Lower Thames Crossing

1.6 The Errata Report (Tracked changes version)

Planning Inspectorate Scheme Ref: TR010032 Application Document Ref: TR010032/APP/1.6

VERSION: 6.0

Appendix A HRA Figure 24

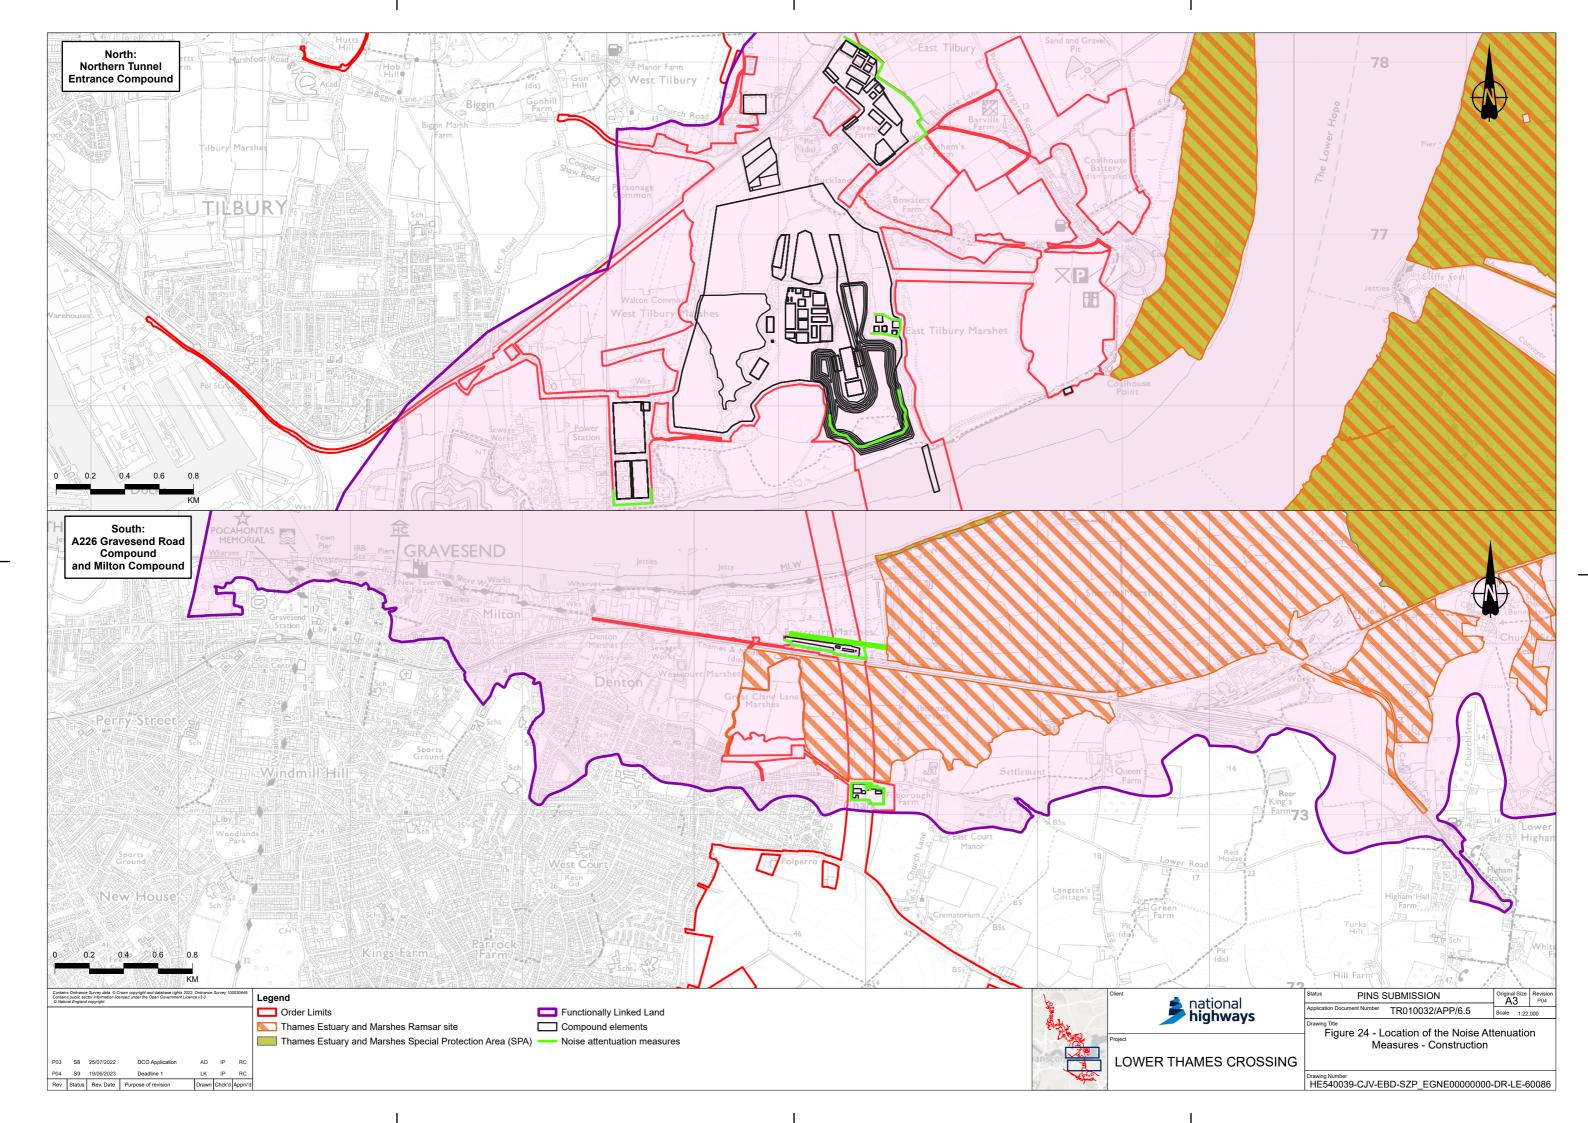
APP-487	S51 Dec 2022	Habitats Regulations Assessment Screening Report and Statement to Inform an Appropriate Assessment	Appendix A Figure 24		North view rescaled to show all noise attenuation measures	Figure updated and found in Appendix A of this document.
APP-487	D1	Habitats Regulations Assessment - Screening Report and Statement to Inform an Appropriate Assessment	Figure 24	Figure missing	Figure is cut off and does not include the full extent of proposed construction noise barriers	Figure updated and found in Appendix A of this document.
APP-495	D3	Planning Statement	Paragraph 5.3.24	Туро	Paragraph says "model provision." Should state "modal provision."	No change, Document not updated at this time.
APP-495	D1	Planning Statement	Paragraph 6.5.78	Area error	Areas of ancient woodland.	No change, Document not updated at this time.
